23 October 2019

Kelly Walker
Environment Canterbury
Timaru Office

OCEANIA DAIRY LTD – RE REQUEST FOR FURTHER INFORMATION

Figure 1: Bird survey areas

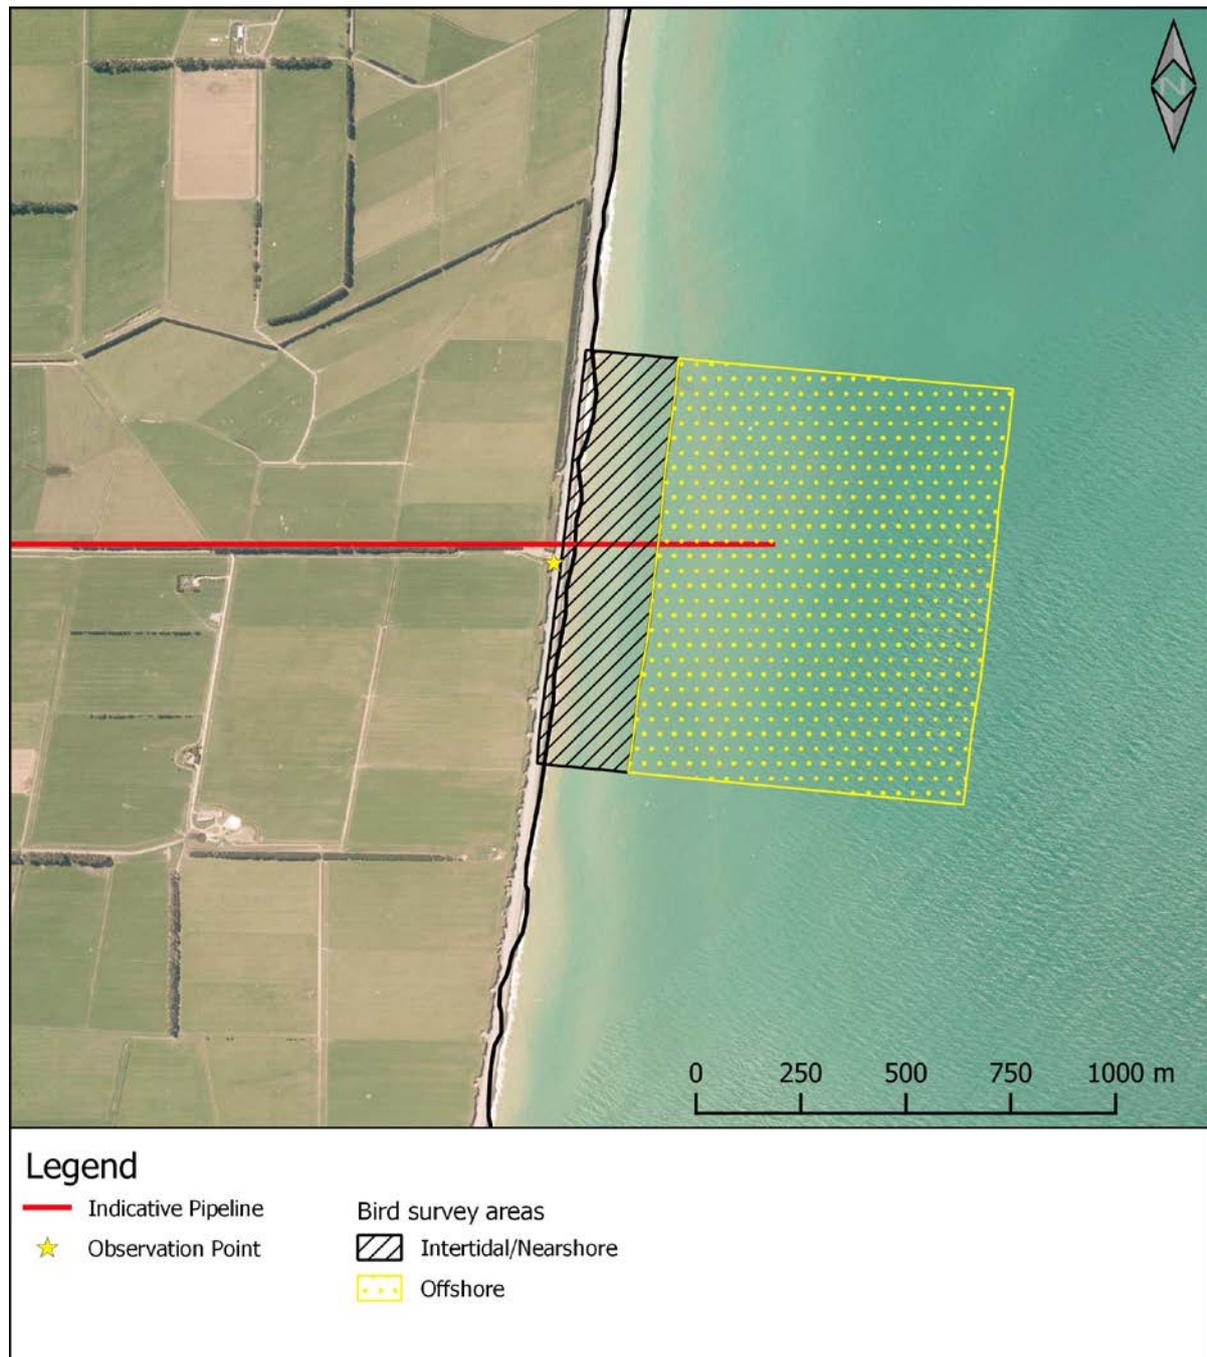
c. A map should be provided showing the survey point, the extent of area surveyed and the proposed outfall pipe.

Figure 1 illustrates the approximate areas where the survey was undertaken. The areas are only approximate as the lack of geographic markers made it difficult to determine exact distances when making the observations.
